CITY OF ALBUQUERQUE

**Re: Lincoln Complex, Building M Renovation
Drainage Report/Grading and Drainage Plan
Engineer's Stamp Date 7-31-2015 (K15/D047B)**

DRAINAGE REPORT FOR TRACTS A, B-1, AND C-1 SANDIA ADDITION

Sheet 1 of Exhibit 1

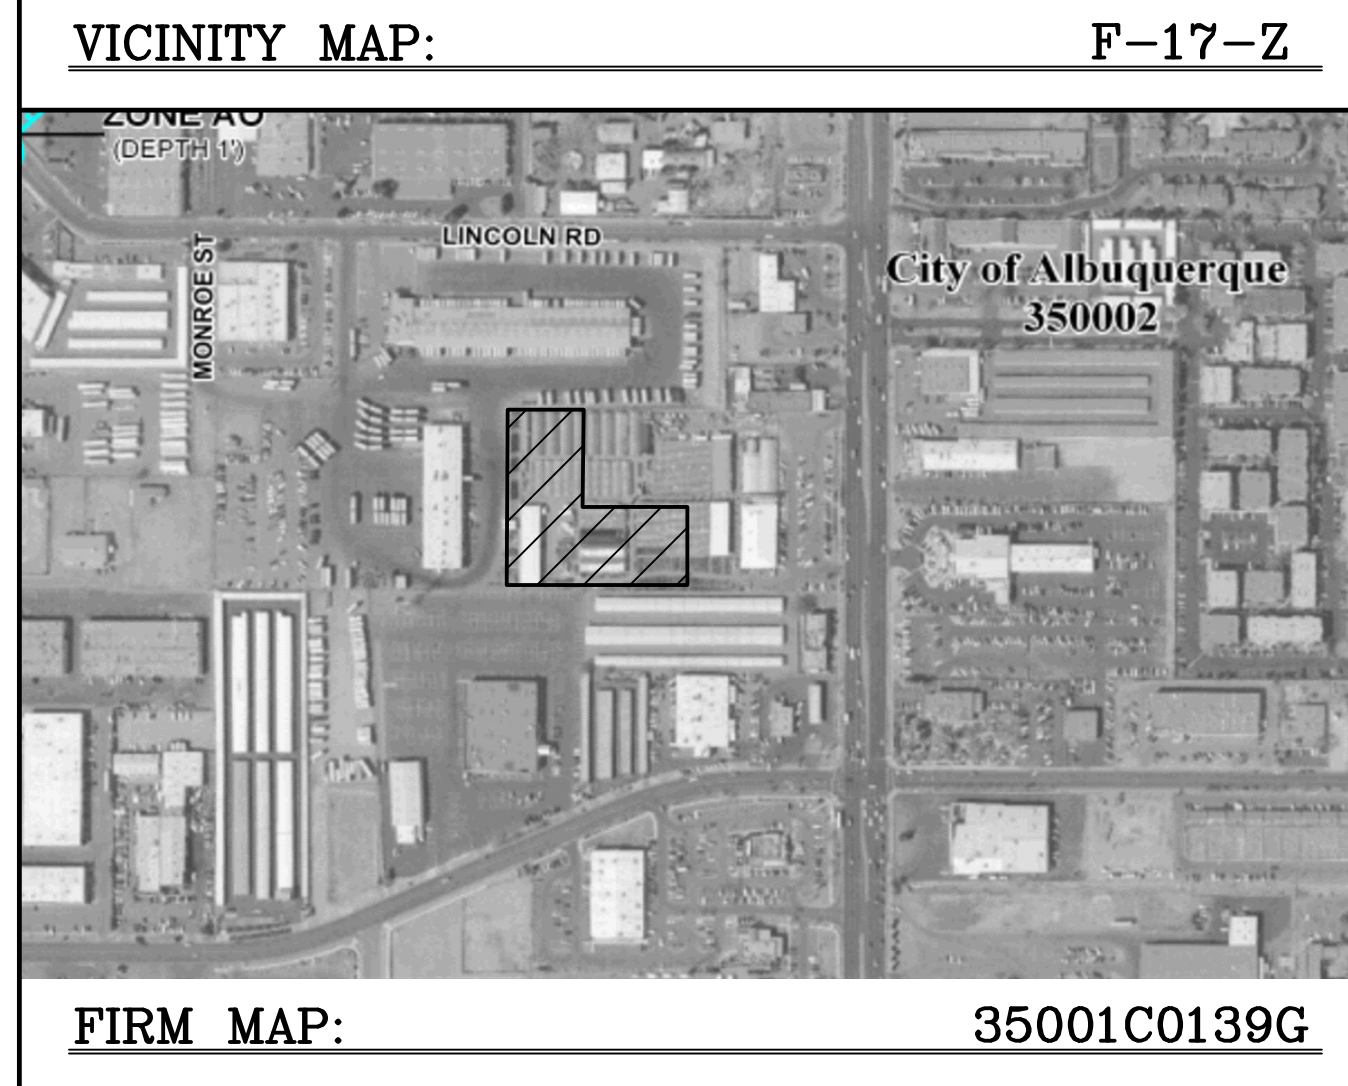
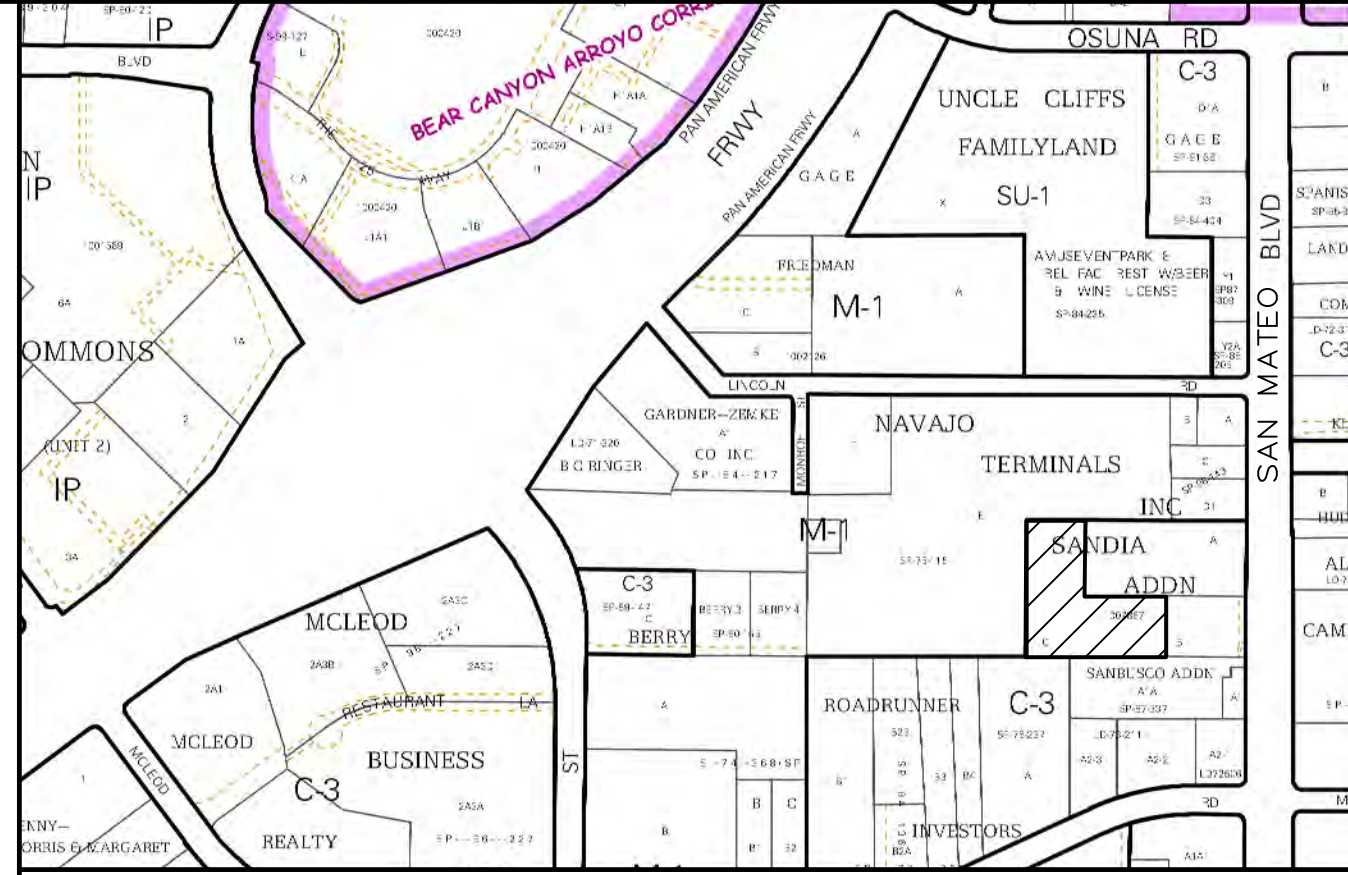
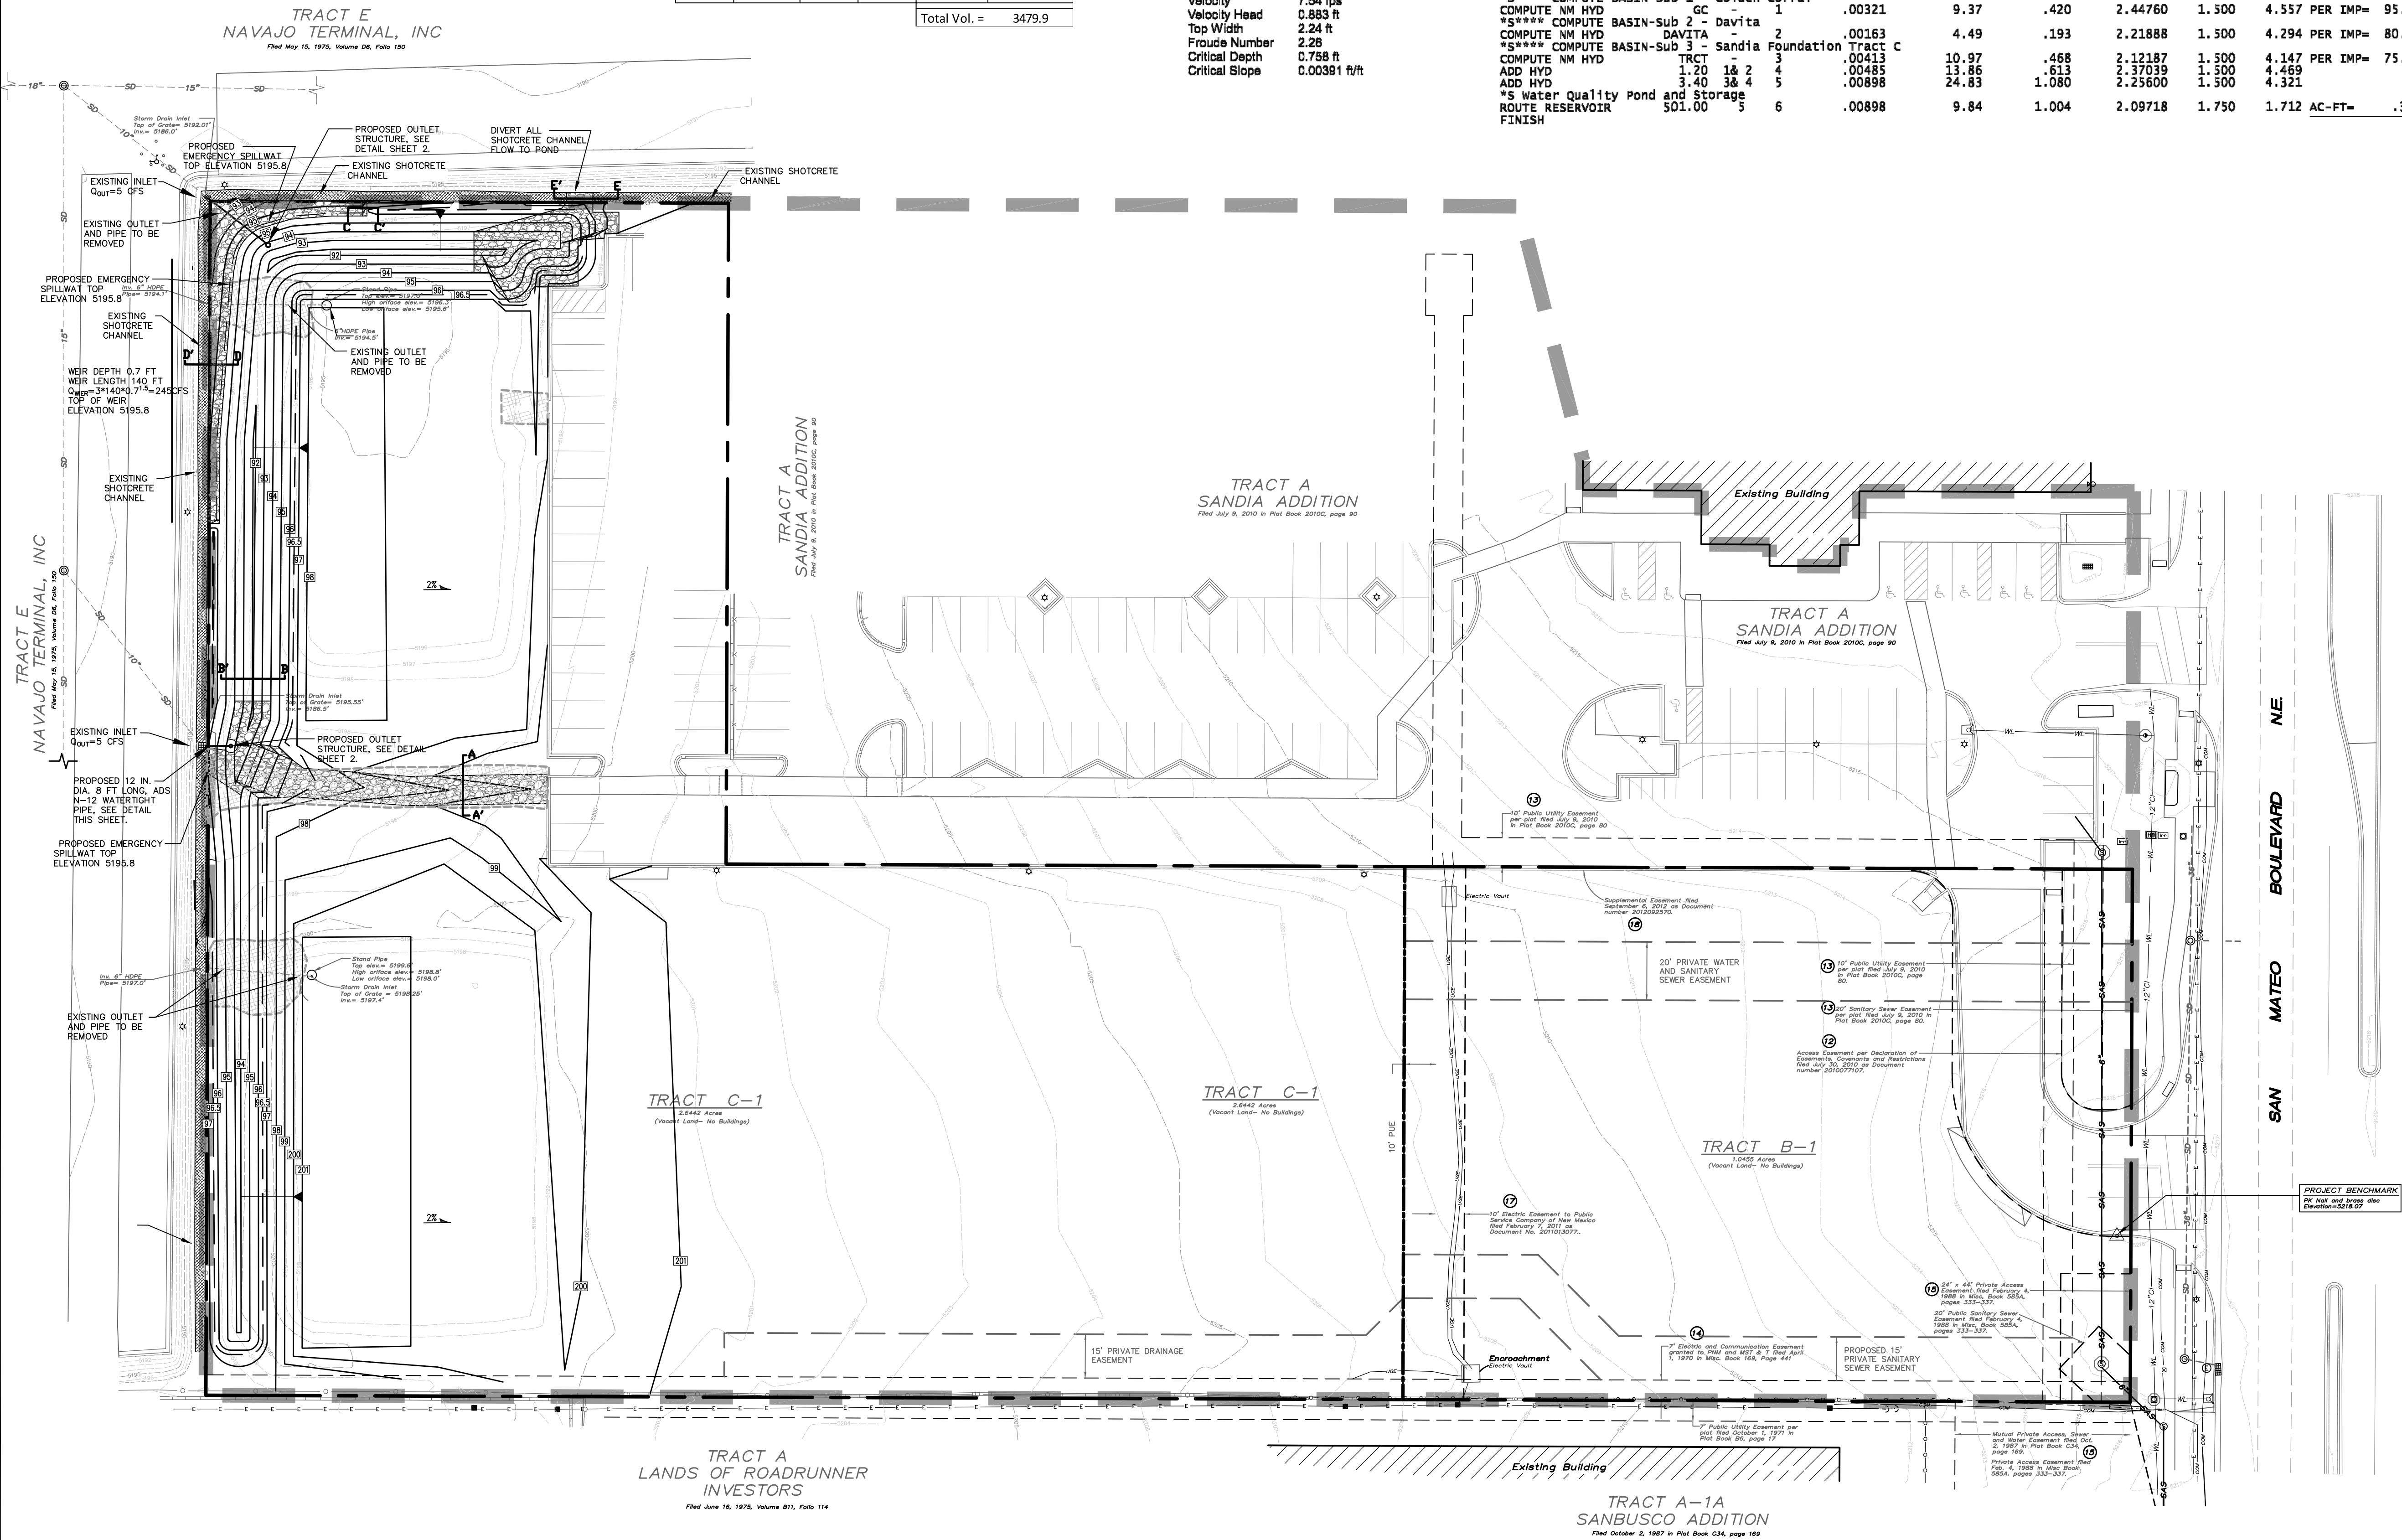
- Provide an exhibit that clearly shows the pipe numbers and inlets number shown Table 4 & 5, Sheet 9 of the drainage report.
- First flush volume (0.34" x Impervious Area) must be provided for the new constructions and all the areas that are being reconstructed.
